UPDATE SHEET

PLANNING COMMITTEE – 1st October 2024

A1 24/00007/FULM The erection of 18 dwellings (100% affordable housing), access, landscaping and associated works.

A2 **23/01494/FUL** **Erection of 9 single storey dwellings including associated access and parking arrangements.**
115 Station Road, Hugglescote, Coalville

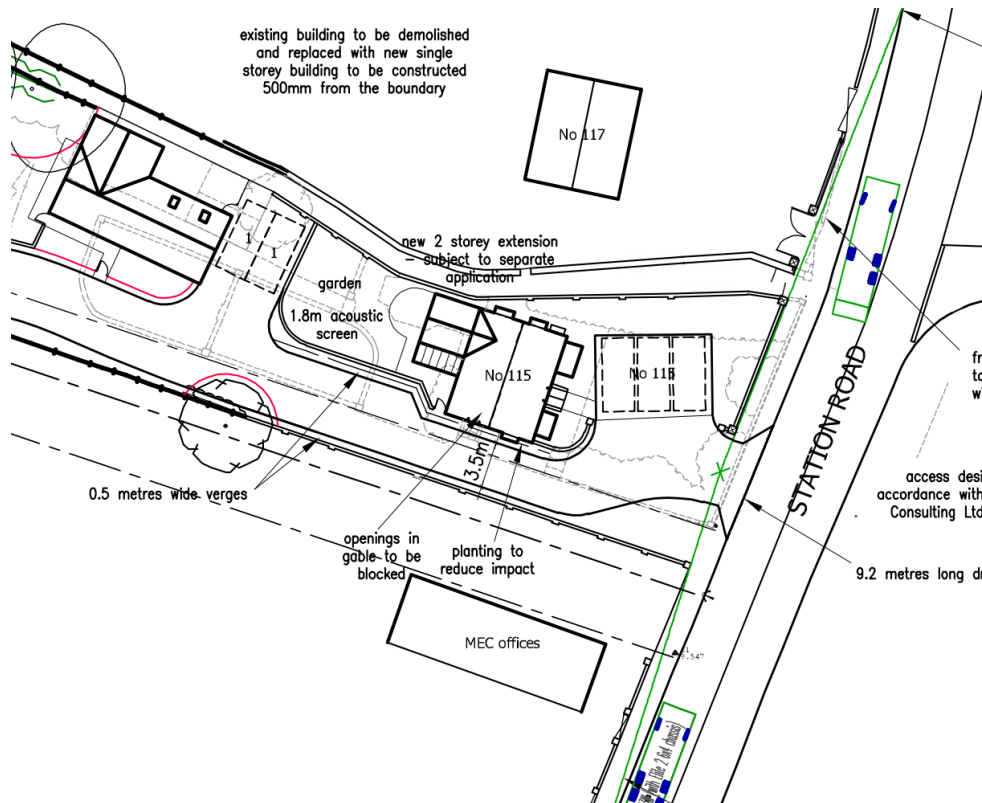
5. What is the increase in BNG, how and where will this be offset?

There is a loss of 0.58 habitat units of neutral grassland, meaning that the overall site has a negative net biodiversity loss of -14.12%. To reach a net balance of 0% the applicant has proposed to purchase 0.58 habitat units of neutral grassland off site through a habitat bank. There is no loss in hedgerow or water habitat, and it is proposed that 0.01 hedgerow habitat units will be secured over the 0.58 habitat units referred to above off site through a habitat bank (so 0.59 habitat units) to secure an overall 1% biodiversity net gain for the whole site. This is in line with the NPPF requirements which requires schemes to make an improvement to BNG on site with new development.

Current application access (23/01494/FUL):

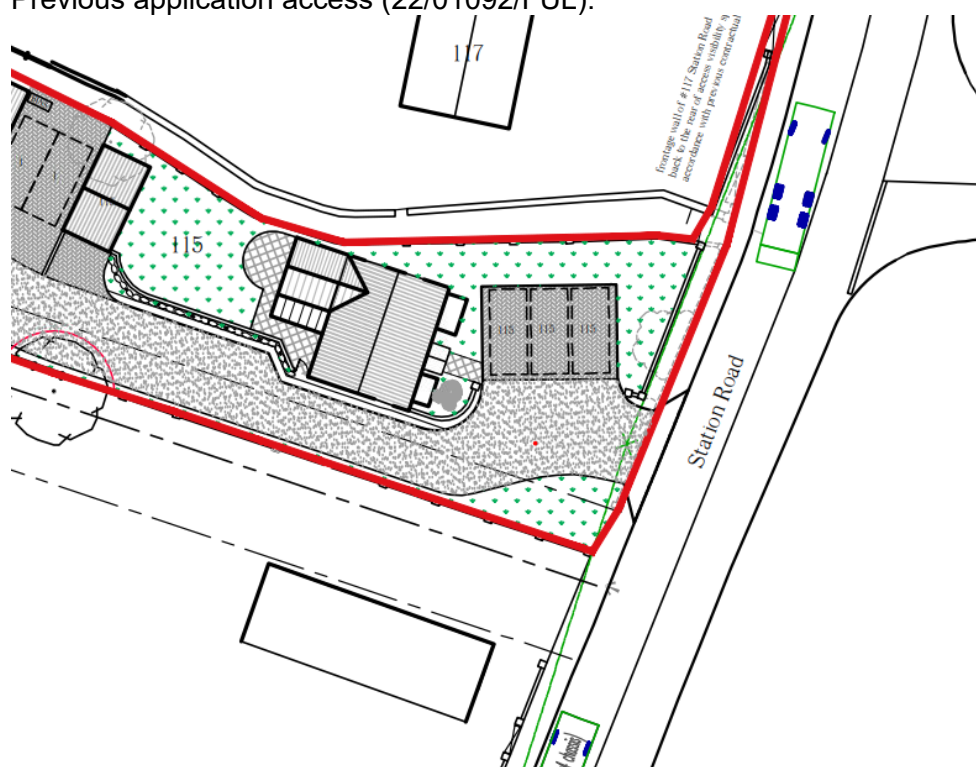
6. Has the access changed from the previous application, where is refuse storage sited and can the site be accessed by emergency services?

The access has not changed from earlier permissions for the site (see below plans). Notwithstanding every case is judged on its own merits and as a full application the current scheme has been assessed and found to be acceptable by highways irrespective of previous permissions.

The LHA accepted the swept path analysis for refuse vehicles which are similar in scale to fire engines. The narrowest point on the access is 3.5m wide whereas a fire engine is typically 2.5m in width. Notwithstanding, it should be noted that building fire safety is covered by building regulations, and fire engines have hoses of up to 23m in length to reach into sites and this isn't a matter to consider as part of the planning application process.
